TO City of Florence Planning Department
FROM Hailey Sheldon on behalf of David Bielenberg and Mike Johnson
SUBJECT Myrtle Glen Subdivision: Addendum to Final PUD Application / Response to Notice of Incompleteness
DATE October 16, 2023
ENCLOSED New Attachments to Final PUD Application:
5. Architectural Plans for Triplexes
6. Paint Colors Plan
7. Depiction of Proposed Design vs Old Town & Mainstreet Architectural Standards

Please accept below our responses (in black font) to your 10/02/2023 Notice of Incompleteness (in grey).

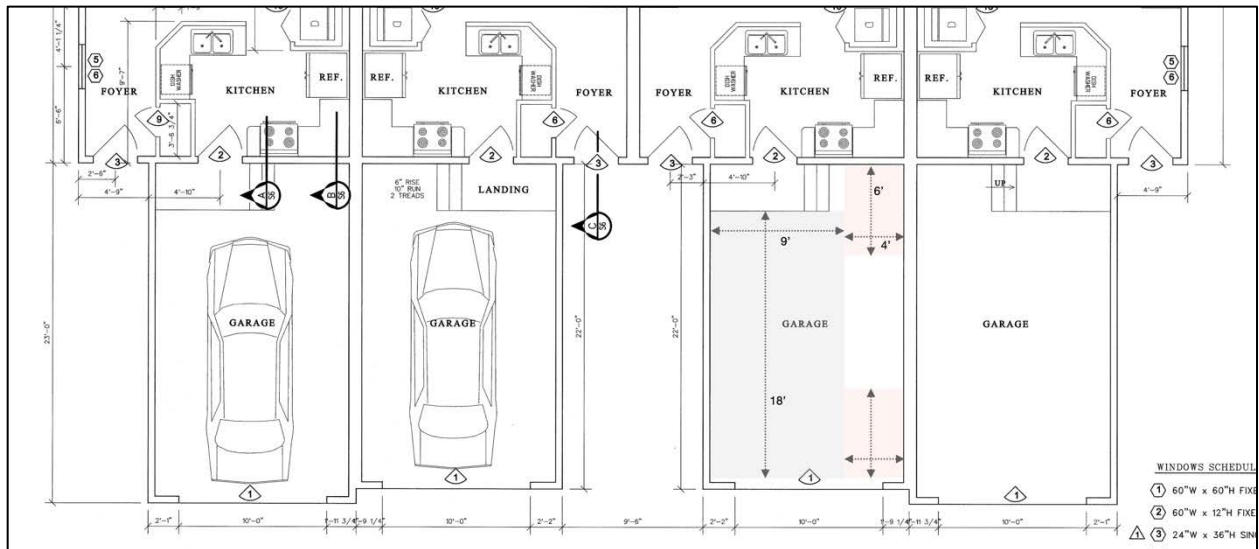
- Applicant states long term bike parking to be located in individual lots. This can meet the condition provided Code criteria of FCC 10-3-10 are met.
 - Interior garage dimensions are not included in Attachment 2. Interior garage dimension are required to allow staff to calculate if FCC 10-3-10 criteria for long term bicycle parking can be met with design as proposed.

Attachment 2 Sheet S2 depicts the interior dimensions of the garages, which are 13 feet wide and 22 to 23 feet deep. See below. The garages fit a standard city parking space (which is wider and longer than the vehicles which use them) and a 4x6’ bicycle space.

SHEET
S9 OF 10

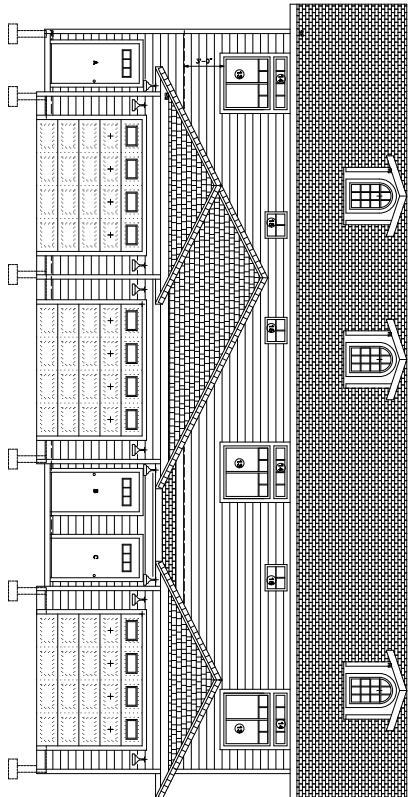
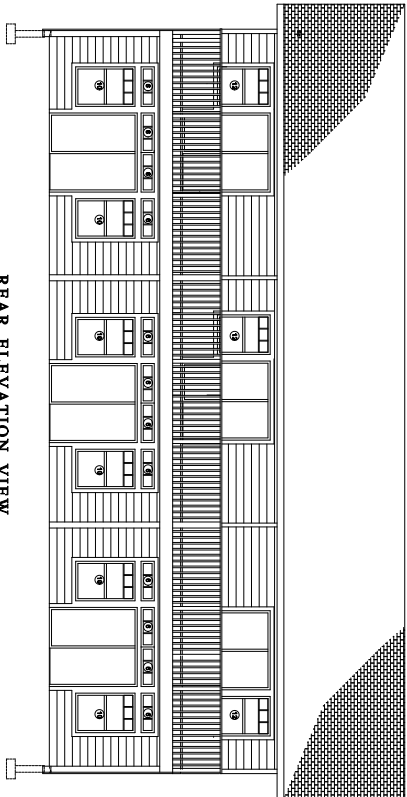
- Condition 7.1 specifically requires each grouping of buildings to include a diversity of building materials, colors, window designs, etc. This condition is not met through Attachment 3 or the narrative statement.
 - All units and buildings appear to have the same materials and colors. This condition is not met.

- Siding variation between buildings: triplex garage gables are proposed to be sided with Hardy cement board shingle patterned siding (as opposed to the Hardy plank horizontal lap siding on the fourplex garage gables).
- Depiction of paint color proposal

- Variation in paint colors between buildings.
- Variation in type of structure (triplexes and fourplexes)
- Variation in garage gable siding between triplexes and fourplexes
